http://www.pacificer.com/~gpimm/		
SIZE A	TITLE Linear Regulator	REV 5
DATE: 5/26/08	REVISED: 12/24/08	SHEET 1 OF 1

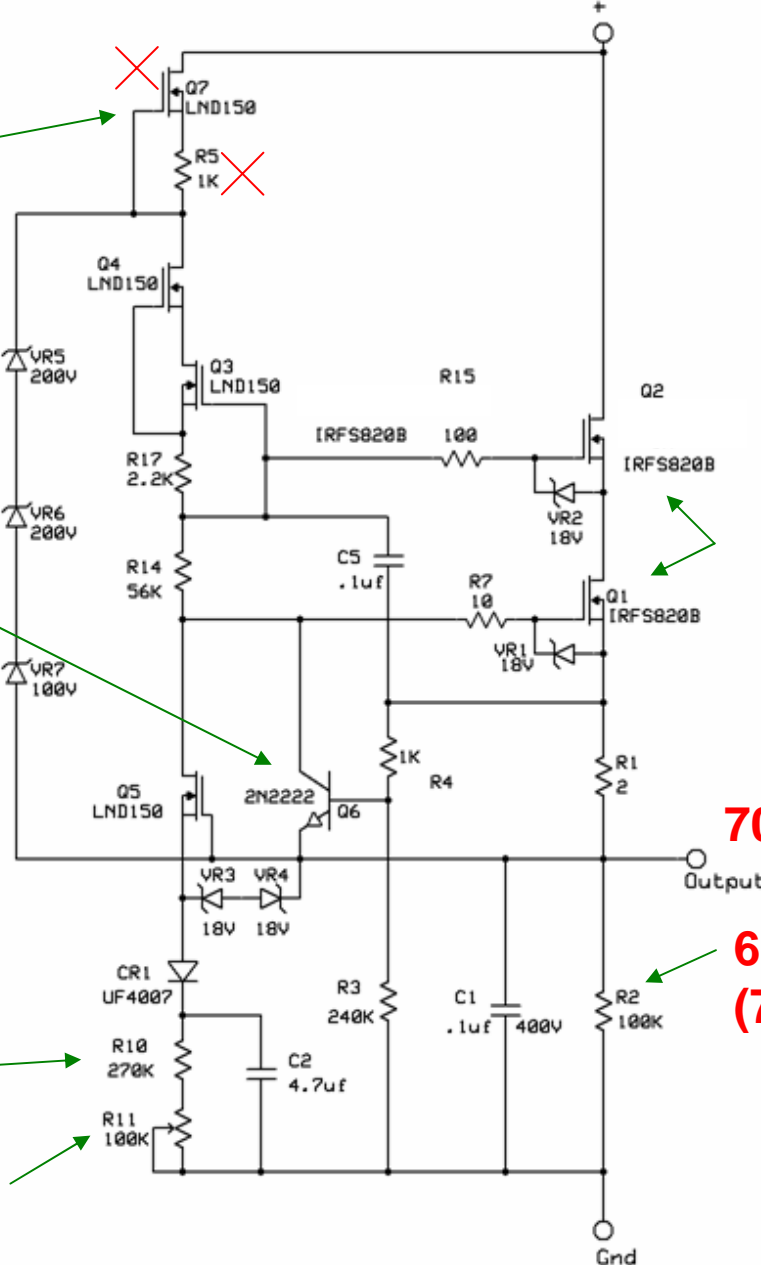
VR5-7, R5
& Q7 were
Omitted cuz
output is only
70V

511-2N2222A
PD=500mW
0.6A
(Gary's spec
wasn't in stock
610-2N2222A)

$r = 70V / .00033A = 212K$
 $212K - 25K = 187K$,
so 180K
(25K = half 50K pot)

50K
Pot

IRFI820GPBF-ND
(insulated sku)

70V out desired

68K R
(70V out / 1mA)
